ITIG TR
PLA

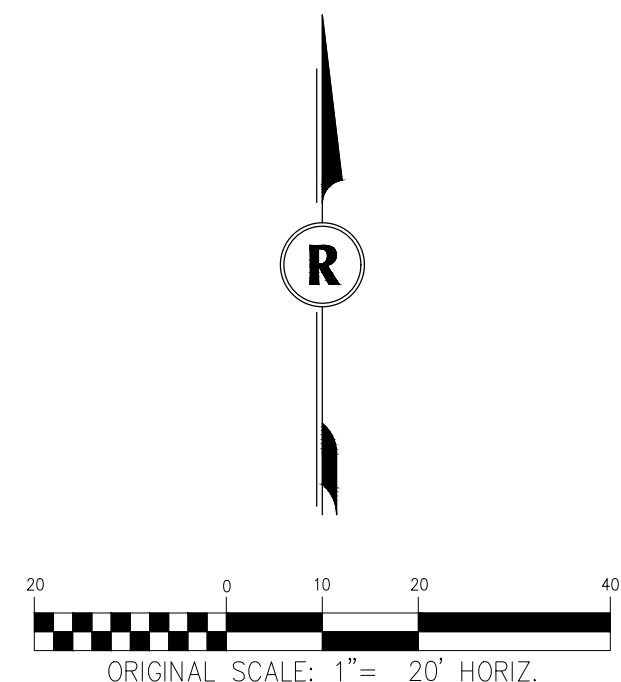
Any trees that are preserved on the site during construction activities shall follow the standard details for Tree Protection per the current Parks, Recreation & Open Space Dedication and Development Criteria manual. Parks, Recreation & Open Space Dedication and Development Criteria manual. These notes shall be added to the plan.

Please show a tree mitigation chart on the landscape plan taken from the Landscape Manual page 29. If payment will be made into the Tree Planting Fund, add another column to the chart indicating the payment amount that will be made. If trees will be planted on the site, please show a symbol indicating trees that are specific to tree mitigation.

NOTES HAVE BEEN ADDED. -RICK

TREE MITIGATION CHART HAS BEEN ADDED. -RICK

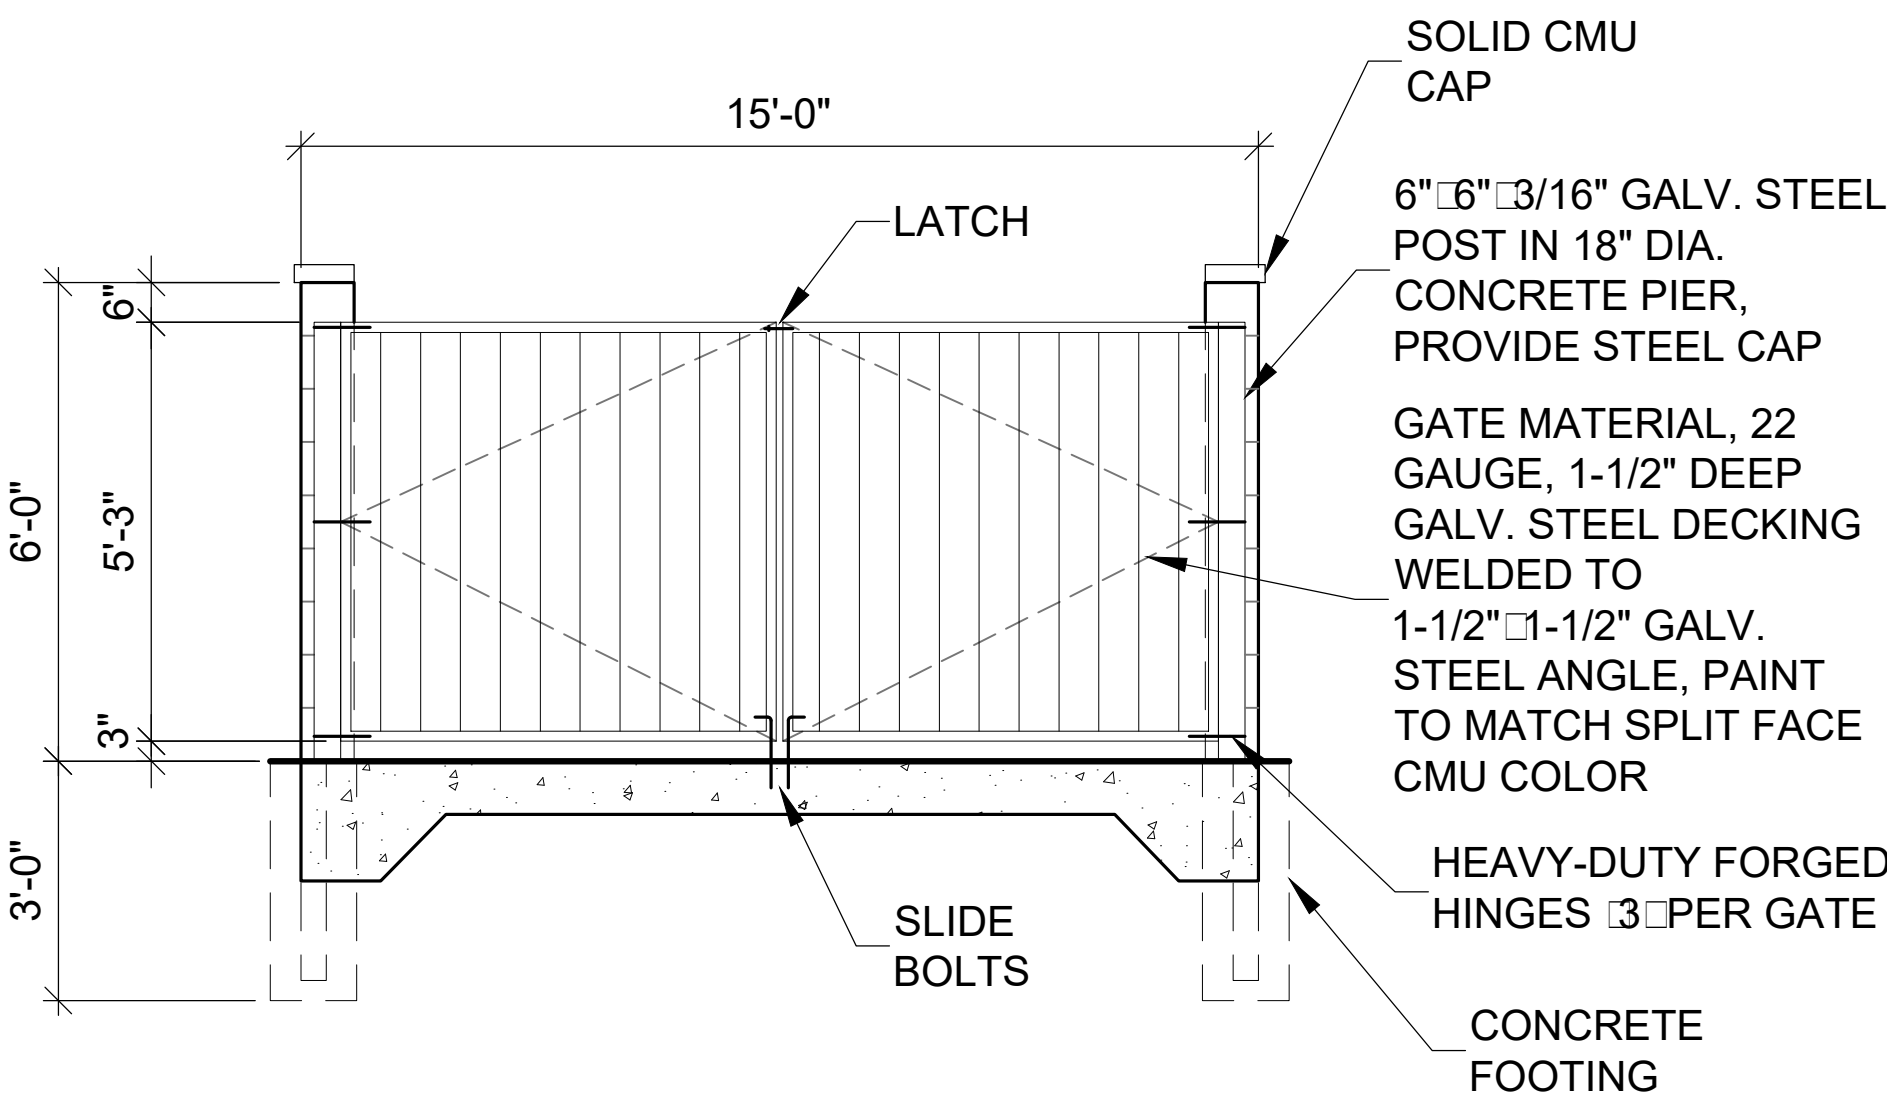
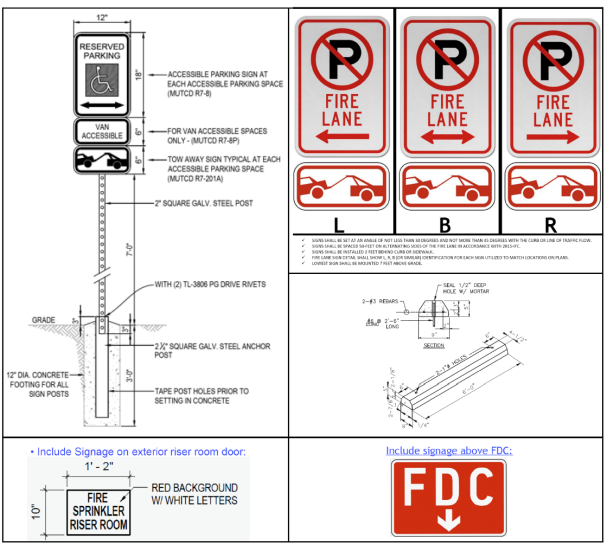
Include a section of the retaining wall

Provide a detail of your mail kiosks on this sheet. Provide enough detail to reflect the accessibility requirements of sidewalks to meet ICC A117.1.

Provide sign package detail. See below for reference.

RETAINING WALL HAS BEEN ADDED ON THE FENCING SHEET -RICK

MAIL KIOSK INFORMATION AND DETAIL HAS BEEN ADDED-RICK

SIGN PACKAGE HAS BEEN INCLUDED IN CIVIL DRAWINGS. -RICK
